IIoT Product End-of-Life Notice

End of Life, Last Time Buy and Replacement Announcement

For immediately release, Advantech is announcing the End of Life (EOL) of [EKI-2728 series](#). The relative replacing models are as below list. Customers who had purchased this Part Number either to purchase any additional rules or migrate to the new replacement models if possible before the EOL's shipment date.

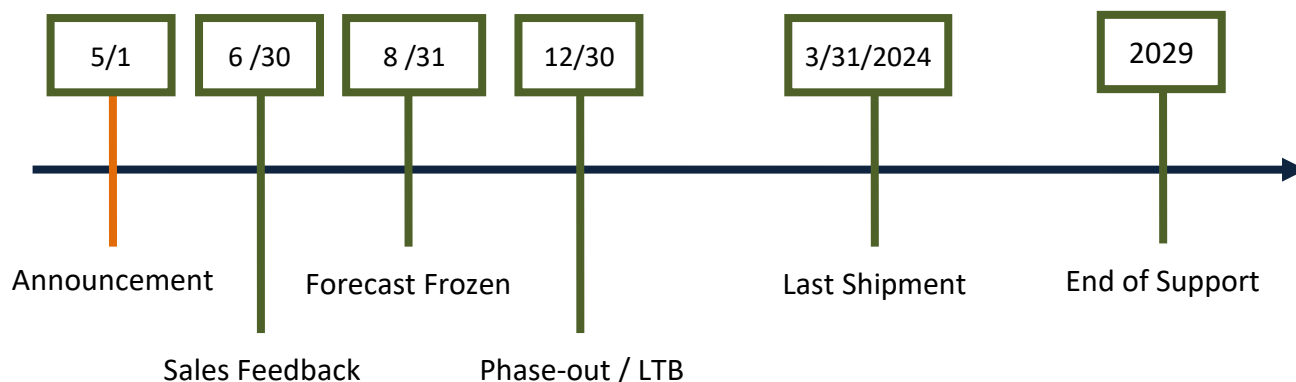
- IC change from RTL8380MI-VB-CG to RTL8370NI-VB-CG for smoother delivery
- Change Din-Rail mounting kit for user friendly

End of Life Product	Suggest Replacement Product	Sample Available Date
EKI-2728-CE	EKI-2728-D	Available Now
EKI-2728I-CE	EKI-2728I-D	Available Now
